Bylong Coal Project

Response to Submissions on Groundwater

Prepared for
Hansen Bailey Pty Ltd

Monitoring bore network

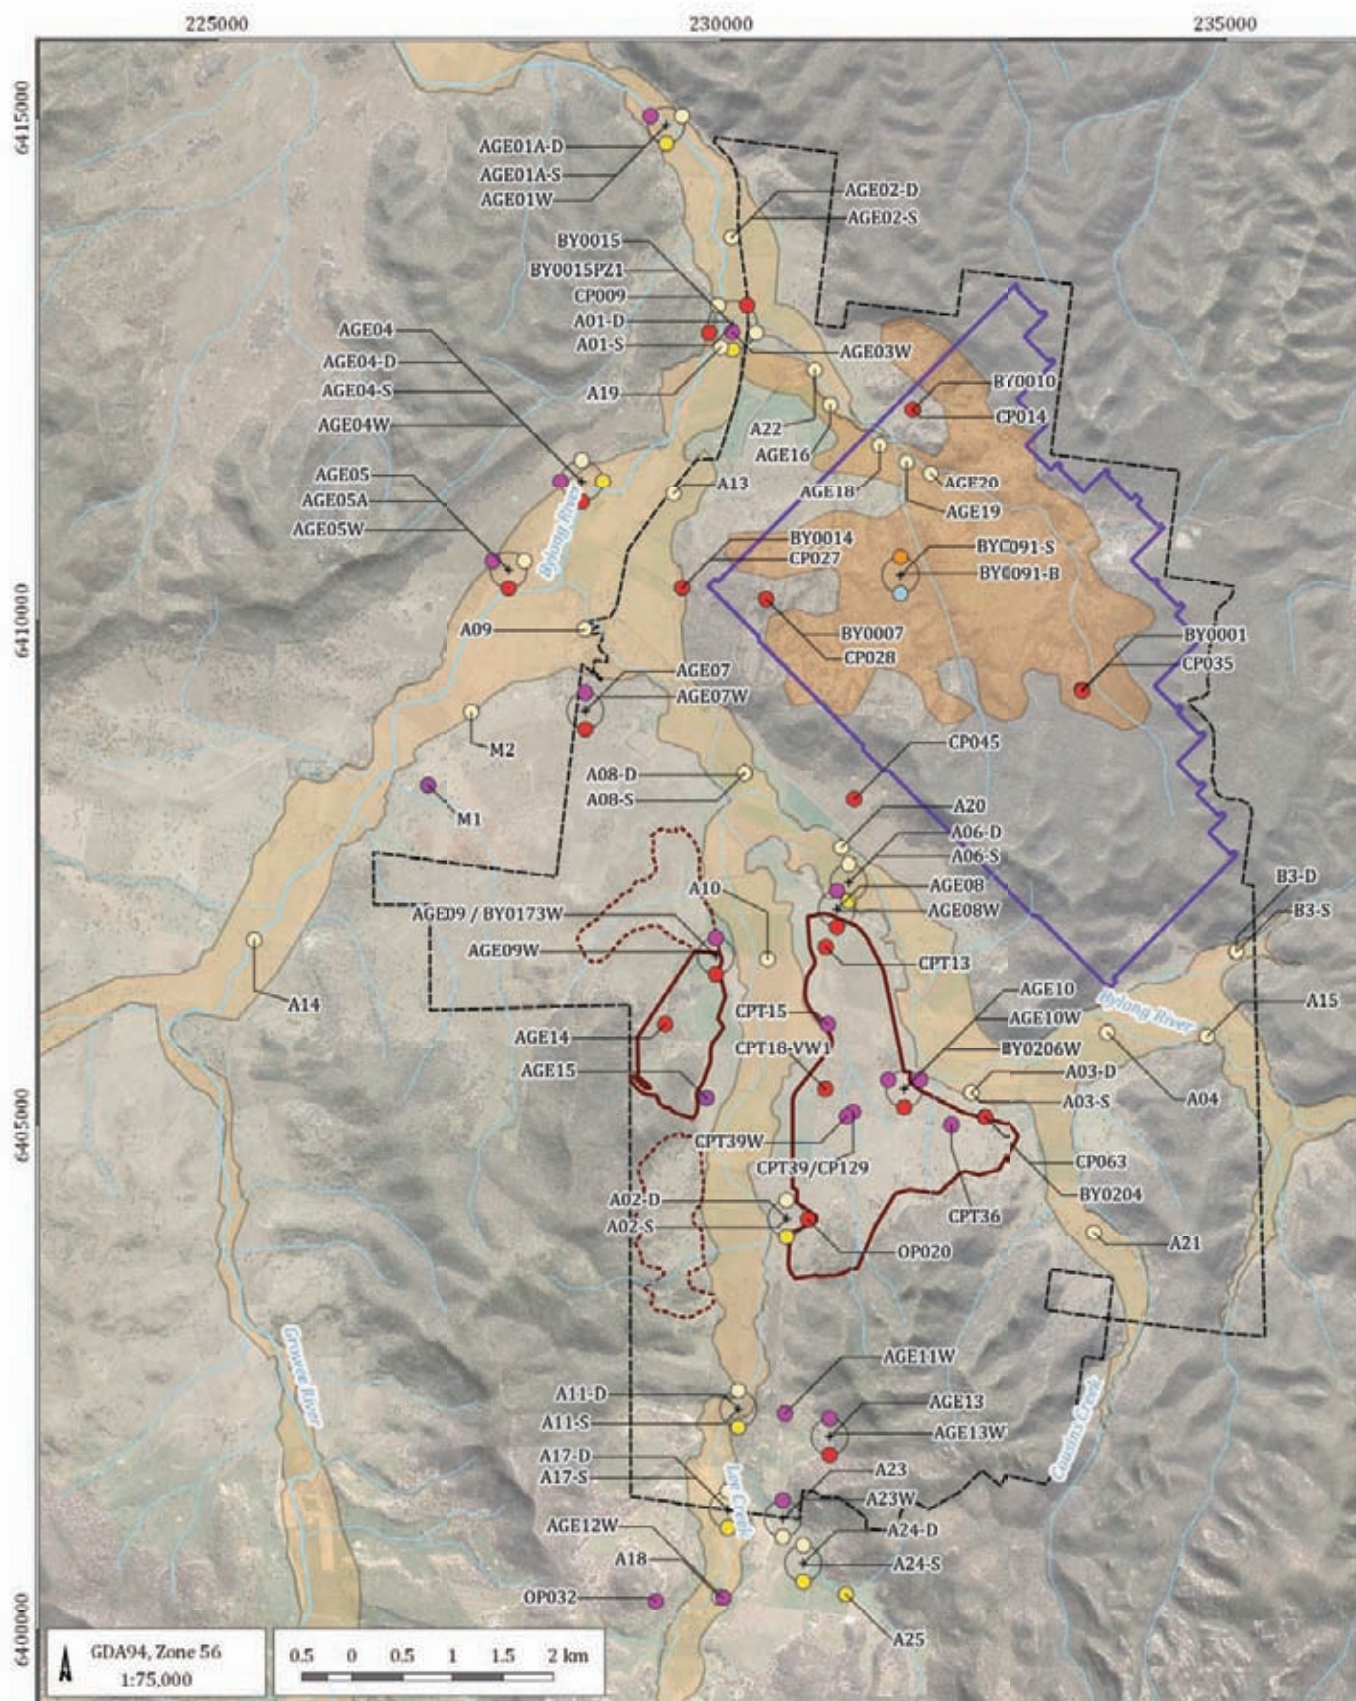
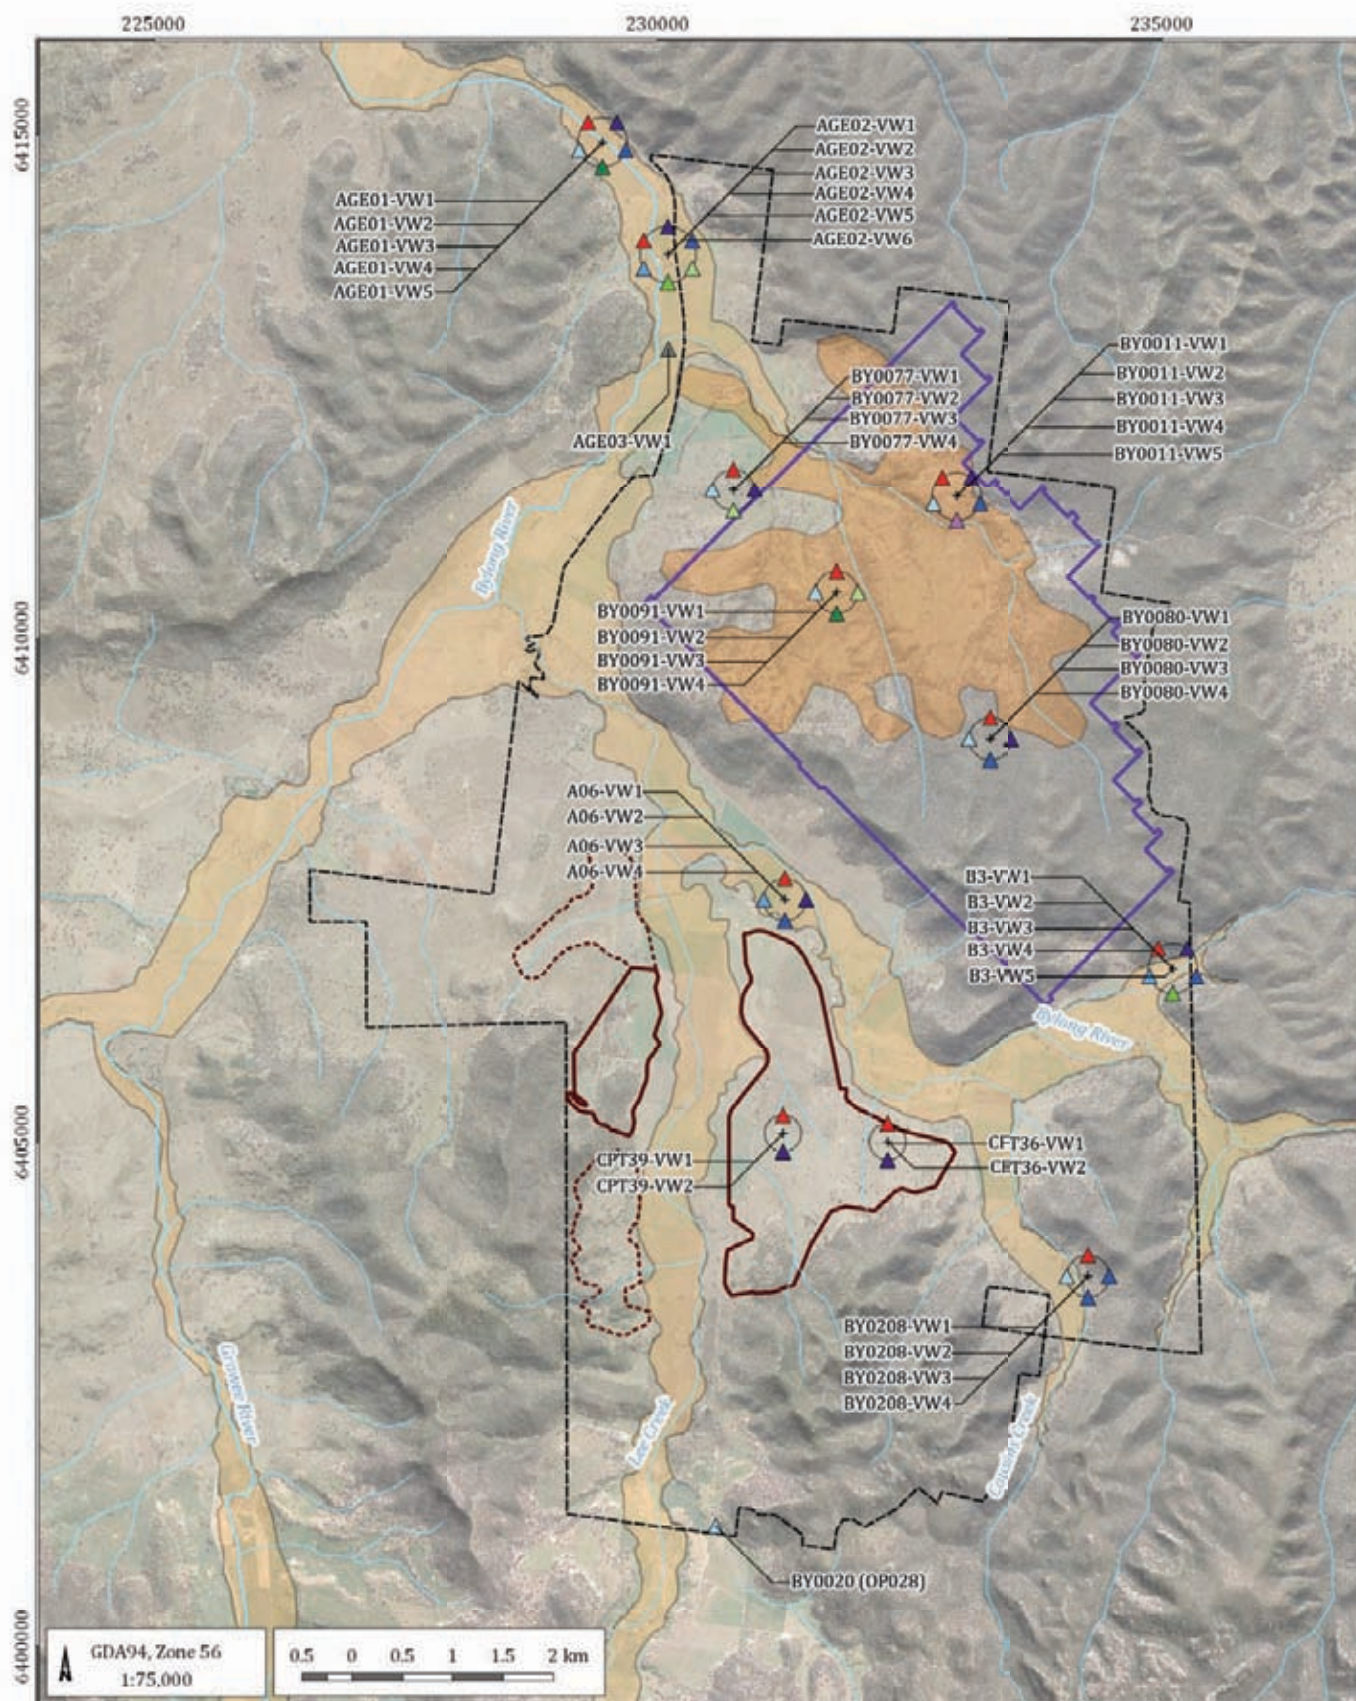
A stakeholder submission has requested further detail on the existing groundwater monitoring network. Specifically local-scale location maps that identify bores based on the aquifer they monitor. The bore summary table from the EIS (based on Table 6.1 in the EIS groundwater report) has been developed further to better identify monitored aquifer units in more details. It is presented as Table 1 below.

Location maps showing the position of the groundwater monitoring network are presented as Figure 2 and Figure 3. The maps show the monitoring bores and the vibrating wire piezometer network separately and the geology of the screen and sensor zones. Figure 2 also shows the locations of the new monitoring bores installed along the alignment of Dry Creek to determine the nature and extent of alluvial sediments within this area.

Figure 2 and Figure 3 show the geographic spread of groundwater monitoring sites within, and proximal to the Project Boundary. Each hydrostratigraphic unit is included in the network with the Quaternary alluvium containing the majority of monitoring points. The alluvium is considered the most sensitive unit to potential changes in groundwater abstraction and hence many of the monitoring bores follow its mapped extent.

Location of cross sections through alluvium

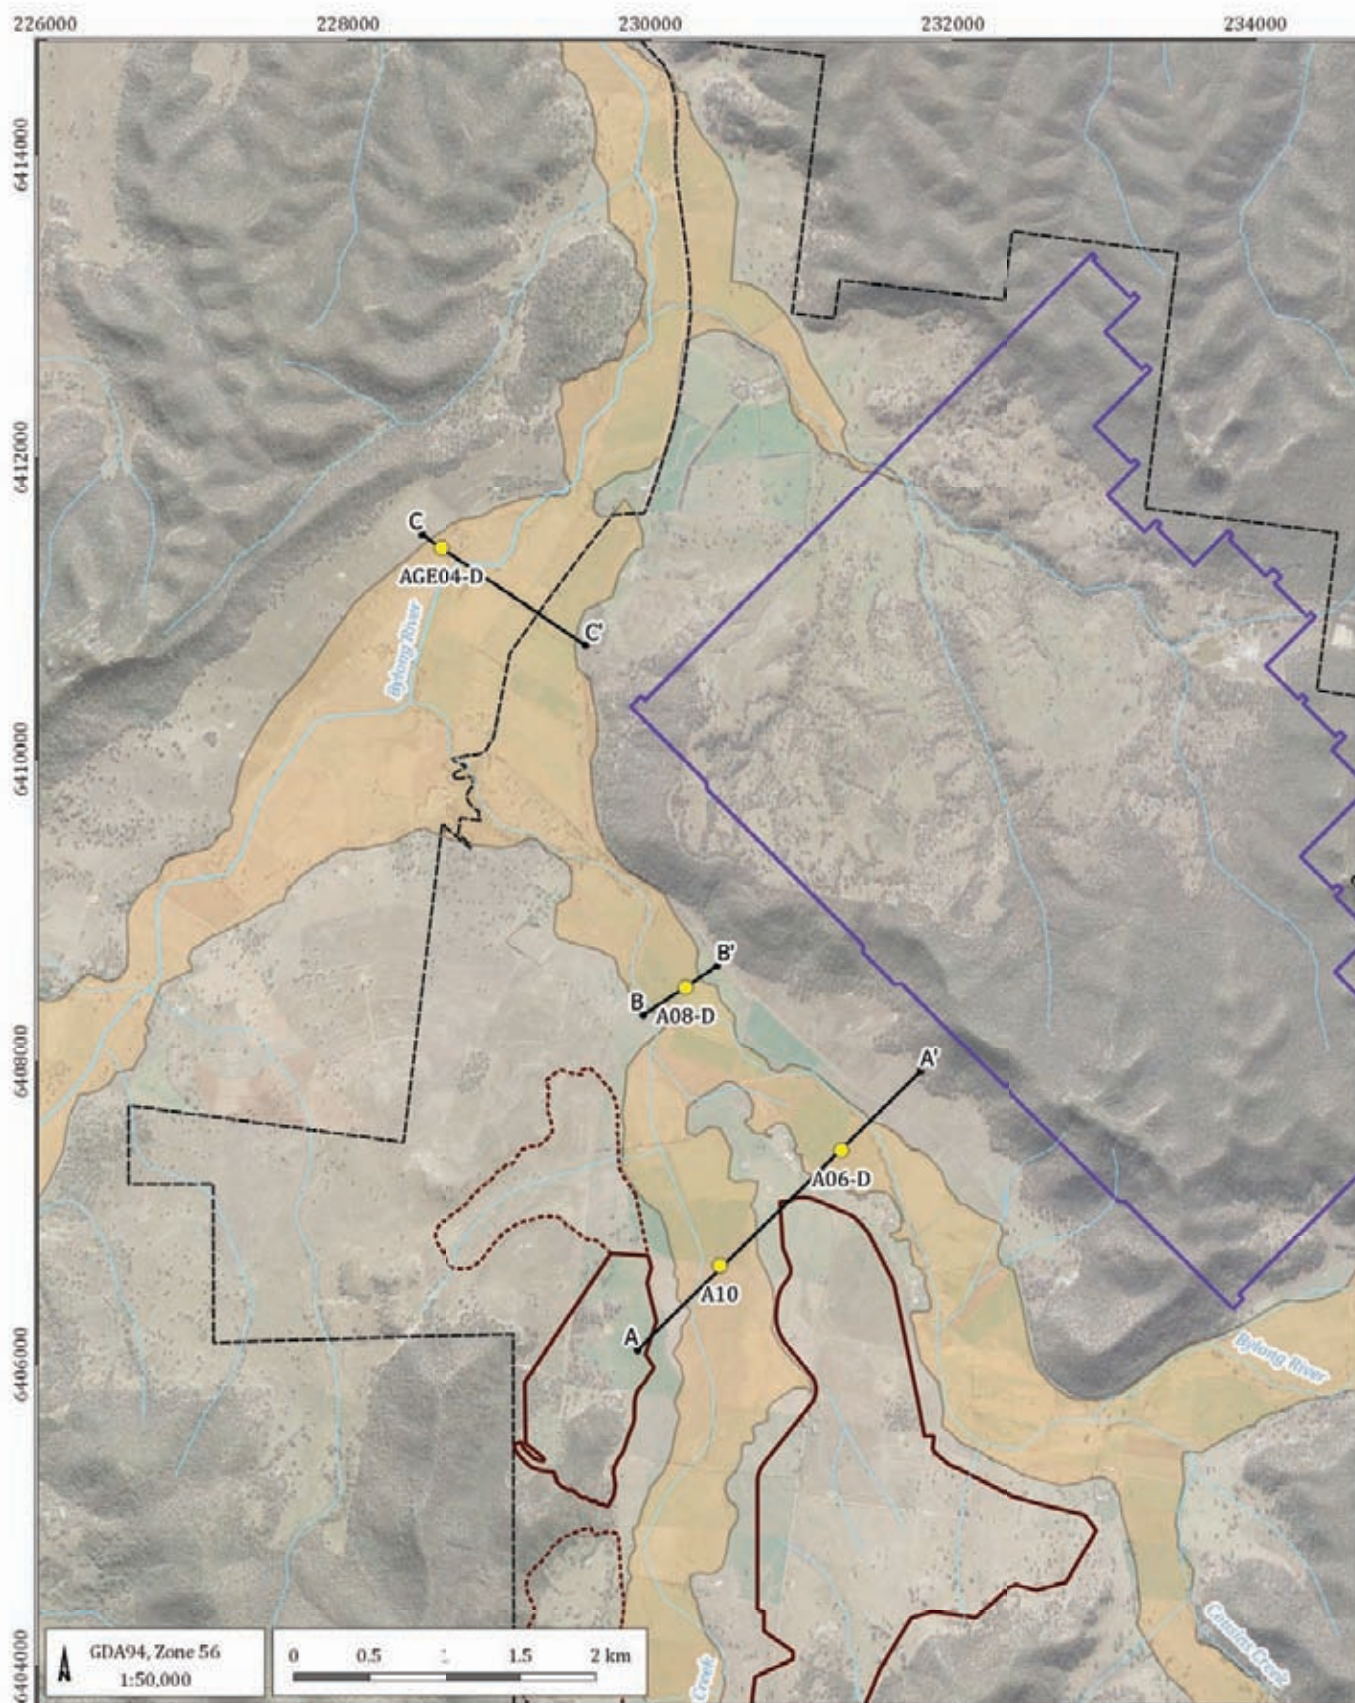
Stakeholder submissions requested more detail on the alluvial aquifer including:

Appendix A contains the borehole logs that show graphically the monitoring bore construction and lithological layers within the alluvium. A series of cross sections were also generated across the alluvial flood plain where detail on lithology was available from monitoring bores illustrating the layers within alluvium.

Figure 4 shows the locations of the sections with Figure 5 to Figure 7 showing the cross sections for each site. The alluvial layers presented within the sections are a simplified representation of the lithology based on the relative permeability. Clean porous sands are separated from less permeable silty sands, clayey sands and clays. The depth of groundwater recorded below the surface is also noted on the cross sections.
